Attachment 2

Technical Specification Bases Revision

9505110296 950502
PDR ADOCK 05000287
P PDR

Oconee Nuclear Station
Figure 3.5.2-16a

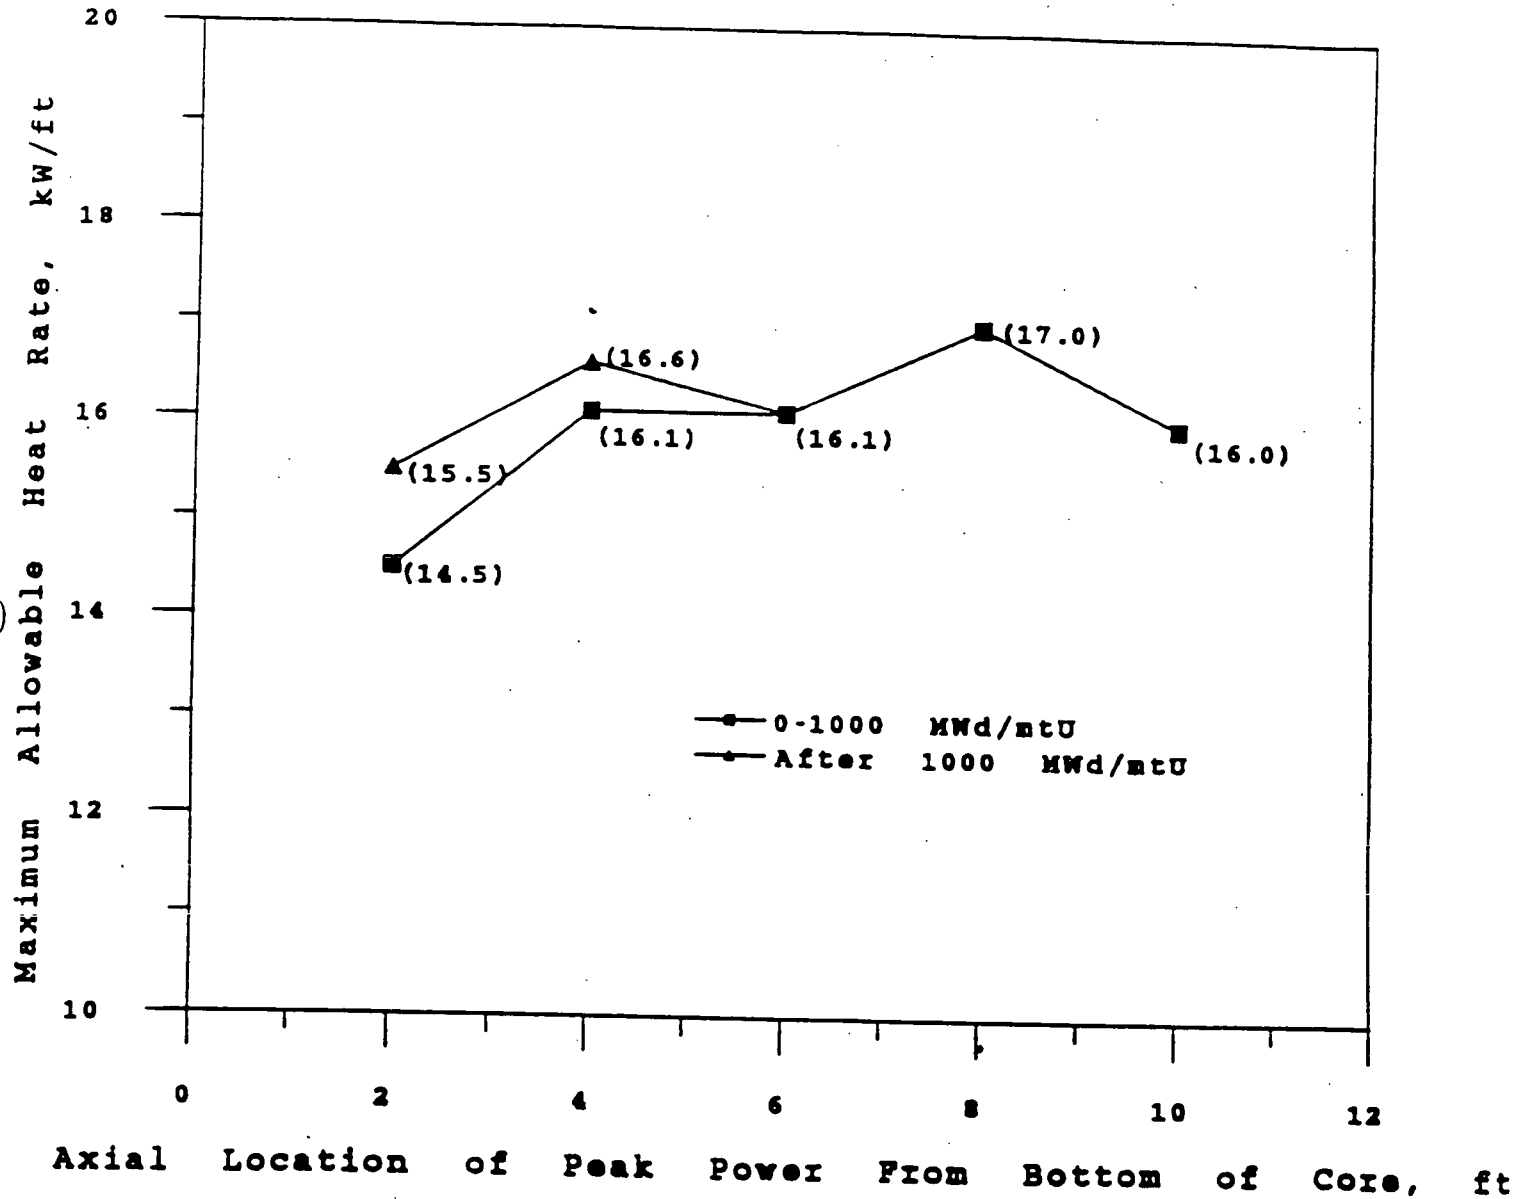
LOCA - Limited Maximum Allowable Linear Heat Rate For Mark
B8* Fuel Rods

* Mark-B8 fuel rods with a fuel pellet diameter of 0.3686 inches are used in Mark-B8 and earlier fuel assemblies.

Oconee Nuclear Station
Figure 3.5.2-16b

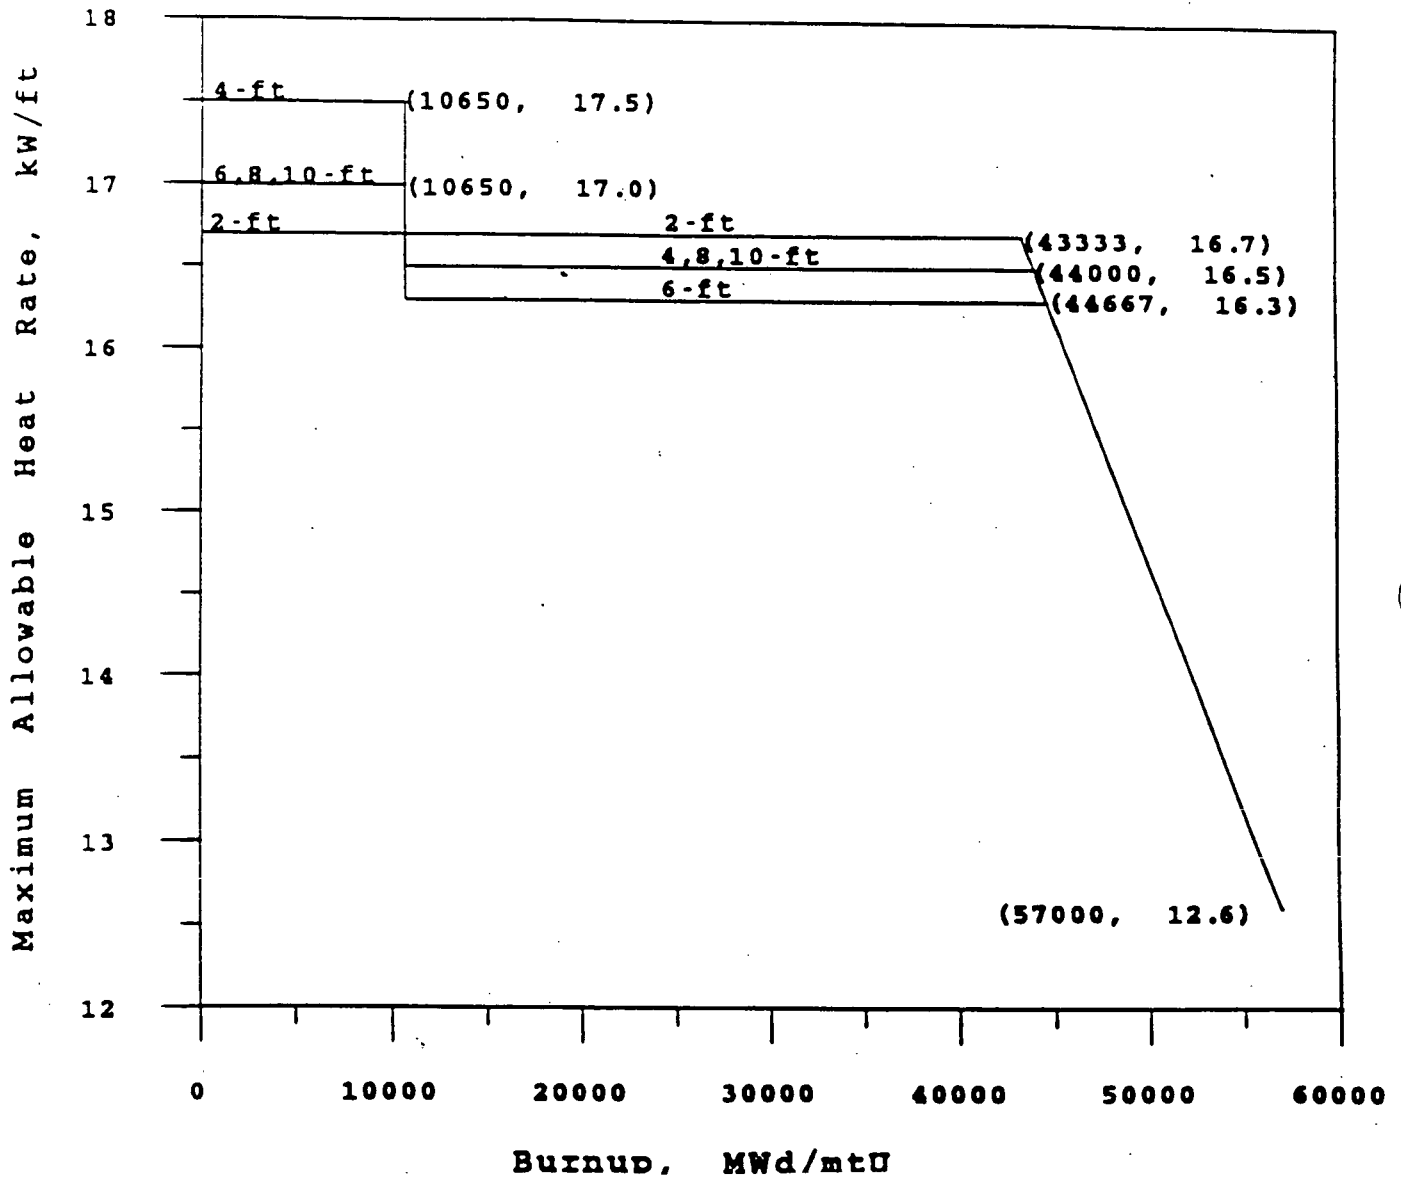
LOCA- Limited Maximum Allowable Linear Heat Rate For Mark
B9* Fuel Rods

*Mark-B9 fuel rods with a fuel pellet diameter of 0.3700 inches are used in Mark-B9 and Mark-B10 fuel assemblies.

Oconee Nuclear Station
Figure 3.5.2-16c

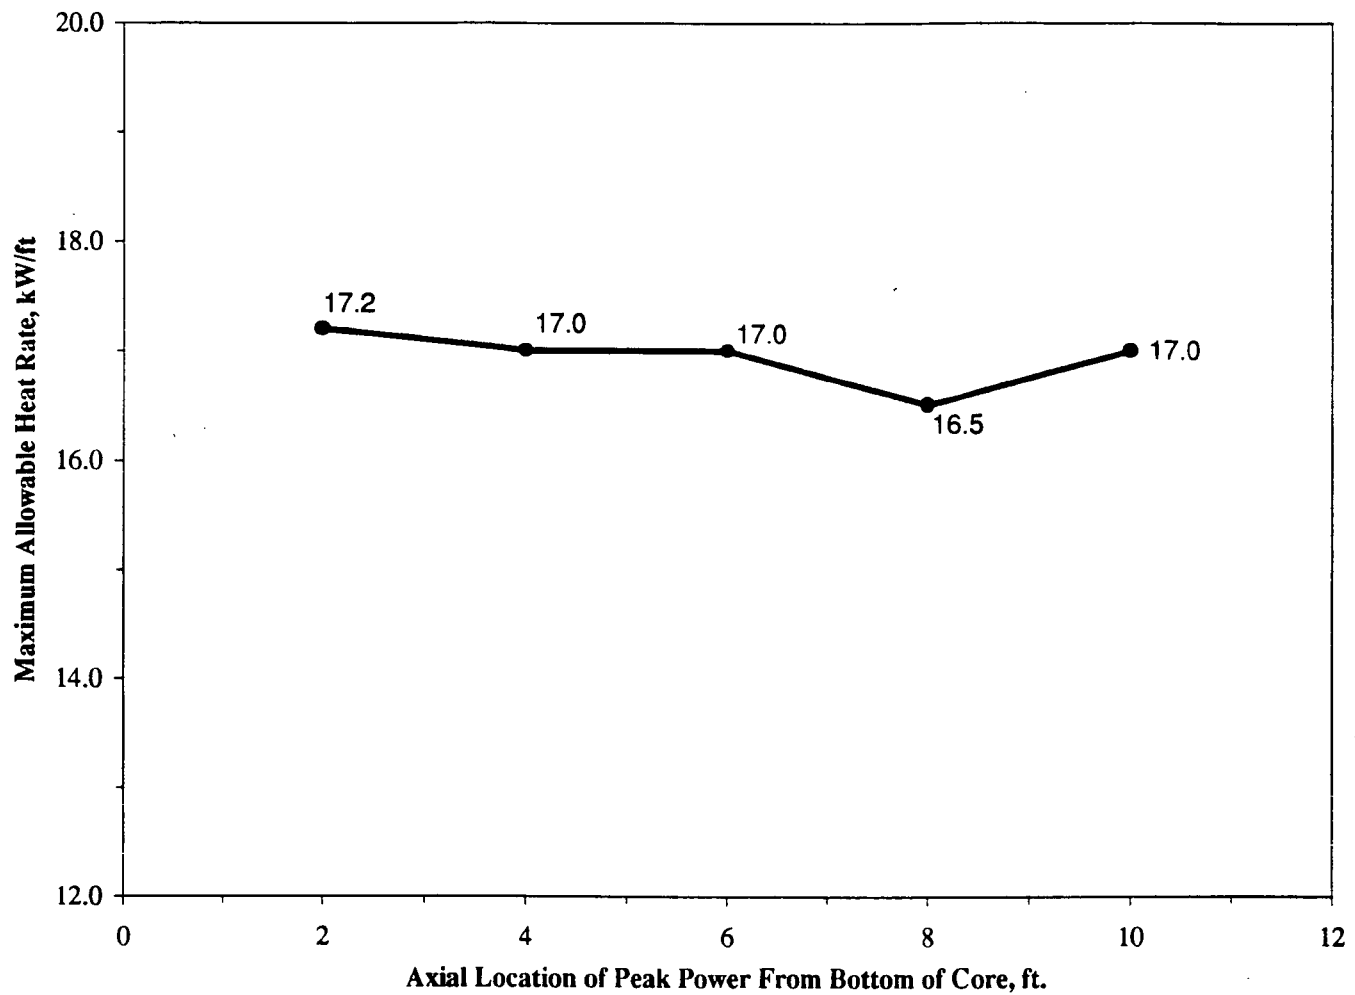
**LOCA-Limited Maximum Allowable Linear Heat Rate For Mark-B10* Fuel Rods,
(BOL - 25,000 MWd/mtU)**

* Mark-B10 fuel rods with a fuel pellet diameter of 0.3735 inches are used in the Mark B10T fuel assemblies.
